Request for Additional Information No. 385(4524, 4515), Supplement 7

U.S. EPR Standard Design Certification

SRP Section: 09.01.04 - Light Load Handling System (Related to Refueling)

DRAFT

Figure 09.01.04-7-1—Loading Pit Gates

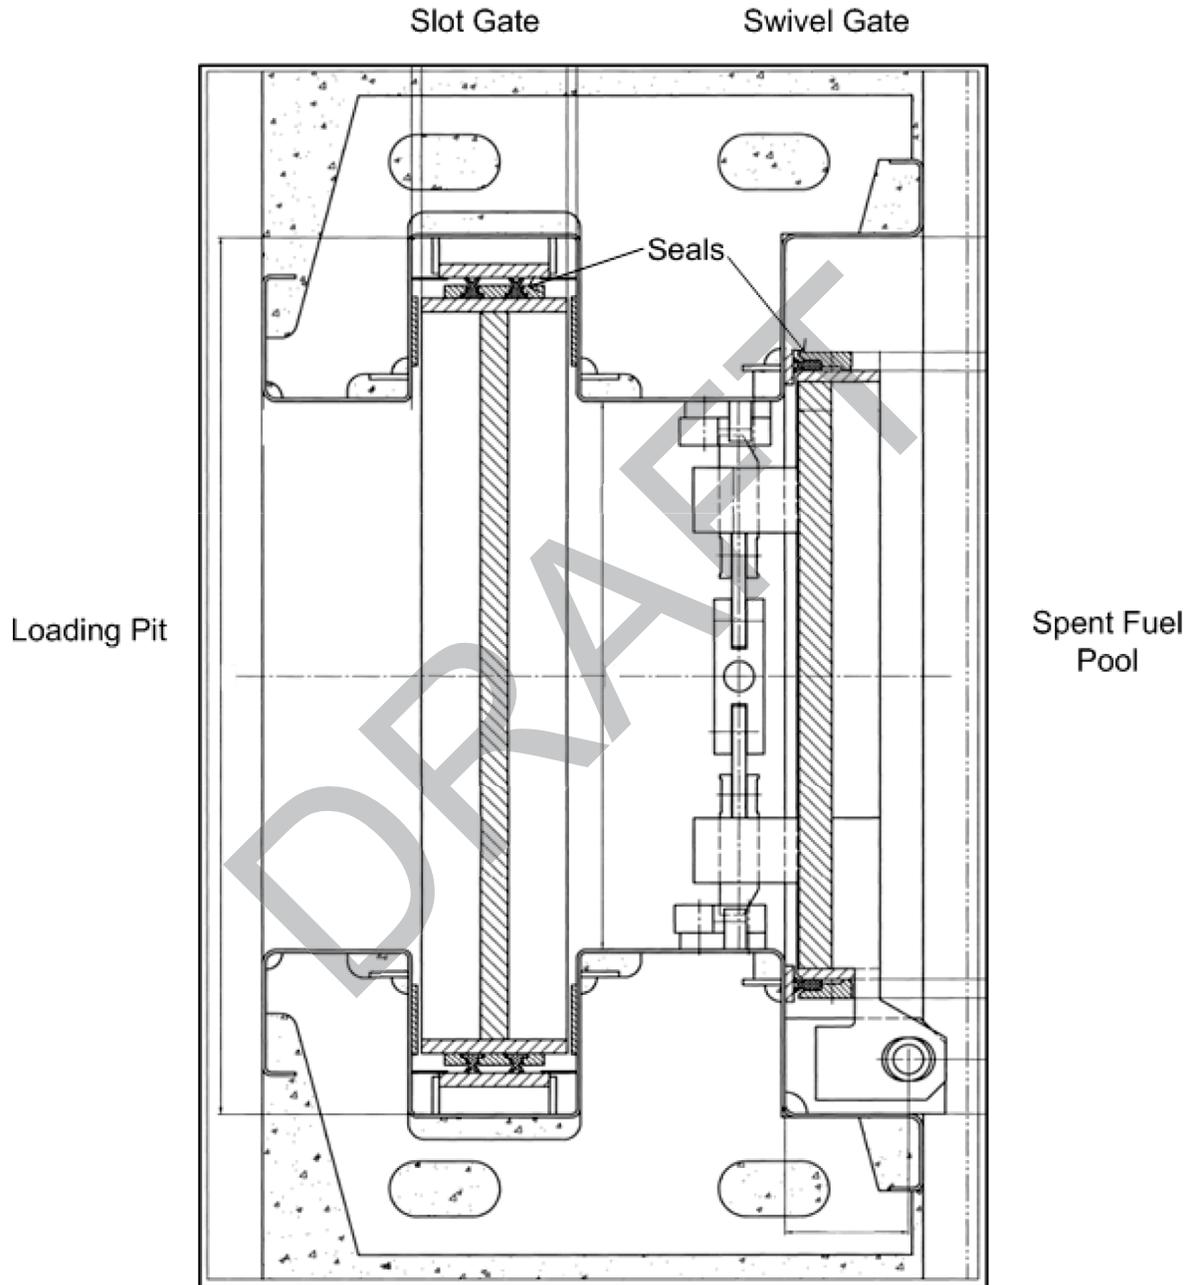
In RAI 9.1.4-7, the staff asked the applicant to provide the methodology for preventing draining of the SFP, when the shipping cask is connected to the bottom of the cask loading pit, assuming a single failure. The response to RAI 9.1.4-7 proposed a markup indicating that the gates and weirs are arranged so that the bottoms of the gates are higher than the top of the stored fuel assemblies.

Two stainless steel gates, a slot gate handled by the auxiliary crane and a swivel gate that pivots manually on hinges to open, separate the SFP from the adjacent loading pit. Both gates are designed to Seismic Category I requirements and support the full height of water in the SFP when the loading pit is empty. The gates do not depend on active components, such as inflatable seals, to maintain leak-tightness. The gate seal material is radiation resistant. A conceptual view of the two gates is shown in Figure 09.01.04-7-1. U.S. EPR FSAR Tier 1, Table 2.2.8-1 and U.S. EPR FSAR Tier 2, Table 3.2.2-1, Table 3.10-1, and Section 9.1.2.2.2 will be revised to include design information regarding the pool gates.

A seismic locking device holds the upper cover in closed position during an earthquake. The gates separating the loading pit from the spent fuel pool are designed to remain leak-tight under postulated conditions, including the safe shutdown earthquake, so that spent fuel pool water inventory is not reduced below acceptable levels.
